Subject: MHI's Responses to the Questions at the US-APWR ACRS Subcommittee Meeting on March 22-23, 2012 Regarding DCD Chapter 9

**Responses to the Questions at the US-APWR ACRS Subcommittee
Meeting on March 22-23, 2012 Regarding DCD Chapter 9**

CHAPTER: 9
CHAPTER TITLE: AUXILIARY SYSTEMS
DATE OF MEETING: 3/22/12

Figure 1: Isolation Valves for SFP Purification Loop

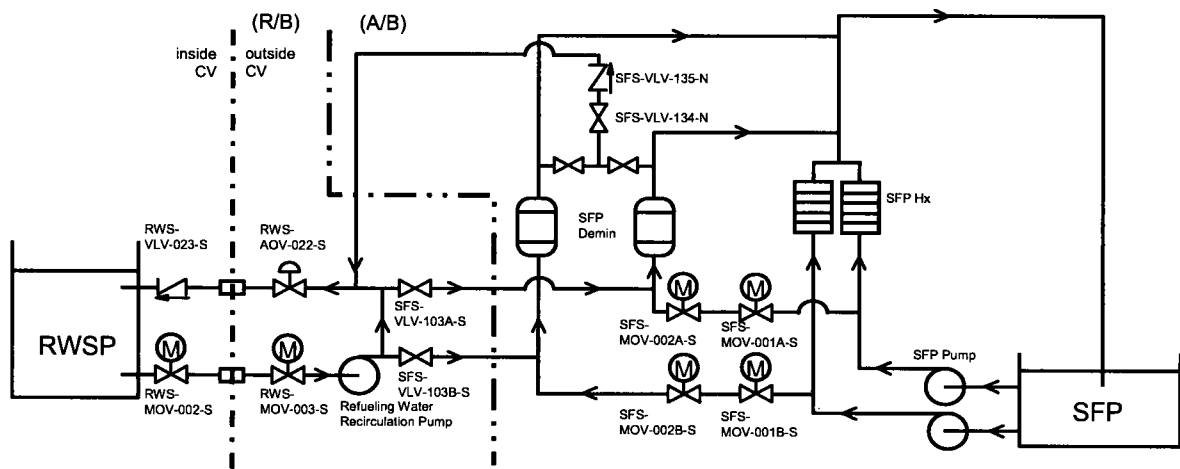
Regarding the RWSP cleanup line, how is the line isolated from the non-safety purification loop in the event the purification loop of SFPCS is ruptured? Consider that the isolation valves installed in the SFP cleanup lines (SFS-MOV-001A,B-S, SFS-MOV-002A,B-S) are now automatic isolation valves, but cannot isolate the RWSP, and the isolation valves installed in the RWSP cleanup lines are still manual valves.

In addition, if the operators had to go in and locally isolate RWSP from this cleanup subsystem because of leakage of this subsystem, are those valves physically located in the room with the demineralizers, or are they outside of that room? In other words, are they accessible, and could they be affected by flow?

As discussed during the ACRS meeting, the isolation valves between the RWSP and the purification portion of the SFPCS (SFS-VLV-103A,B-S) are manual valves and operator action is required to close these valves. These valves are located in an area where operation could be affected by postulated SFP demineralizer leakage. However, an operator is not required to use these valves to isolate the RWSP. As shown in Figure 1, closing the containment isolation valves installed downstream of the RWSP (RWS-MOV-002-S, RWS-MOV-003-S, and RWS-AOV-022S) will isolate the RWSP from the purification portion of the SFPCS; these valves can be operated remotely from the MCR. These valves are located in the reactor building (R/B), i.e. physically separated from the SFP demineralizer rooms which are in the auxiliary building (A/B); thus, operation of these valves would not be affected by SFP demineralizer leakage.
